ADDENDUM NO. 1

R/W Widening, Airfield Electrical and Pavement Rehabilitation (Base Bid)
Taxiway A Extension (Additive Alternate Bid No. 1)
at
Ennis Municipal Airport
Ennis, TX

TxDOT CSJ NO. 2618ENNIS

**R/W Widening, Airfield Electrical and Pavement Rehabilitation (Base Bid)
Taxiway A Extension (Additive Alternate Bid No. 1)(**

3 JUNCTION BOX DETAIL
N.T.S.

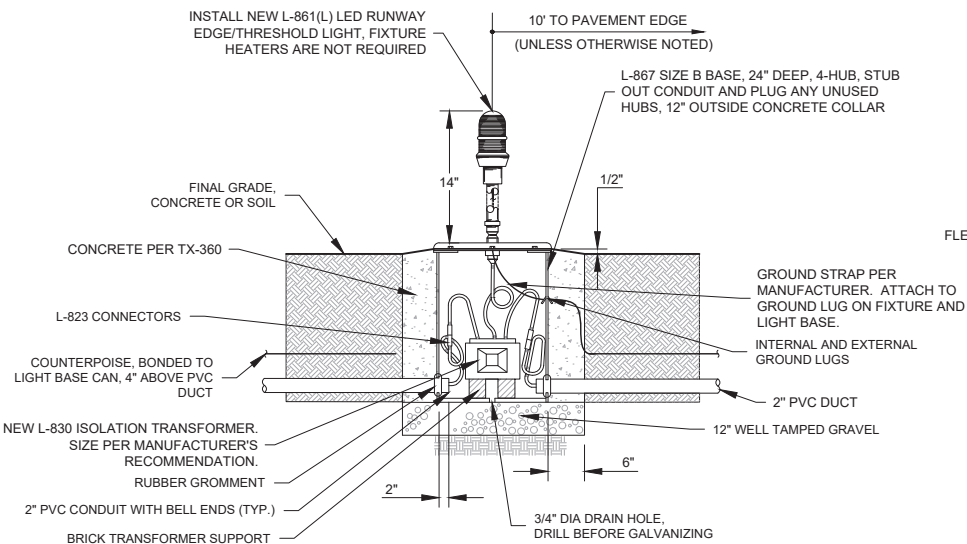
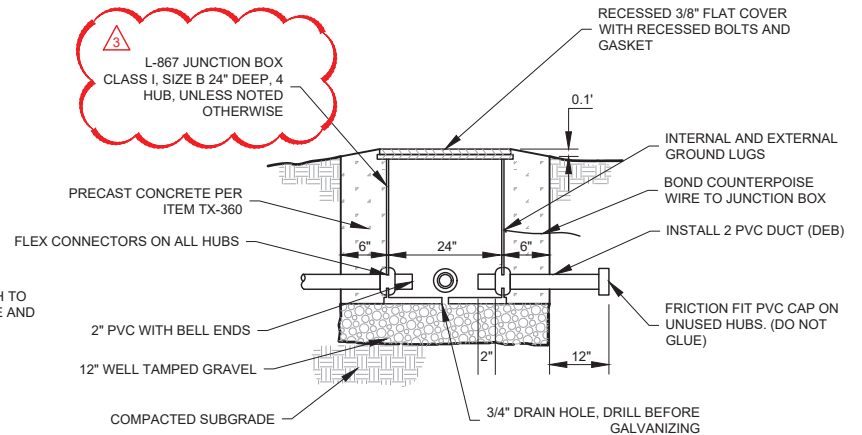
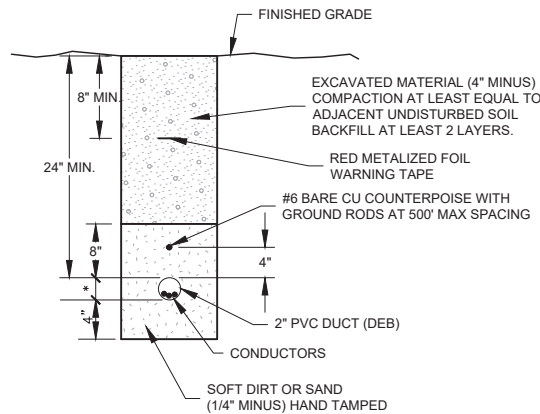
- i. Sheets E201 through E207 – Sheets were updated with information based on Contractor questions. (see Clarifications/RFI Responses below).
- j. Sheet E250 – Junction box detail was updated to L-867B.
- k. Sheet E253 – Wire callout was updated and notes added.
- l. Sheet E254 – Beacon updated to L-801A and notes updated.
- m. Sheet E256 – Radio controller added and notes added.
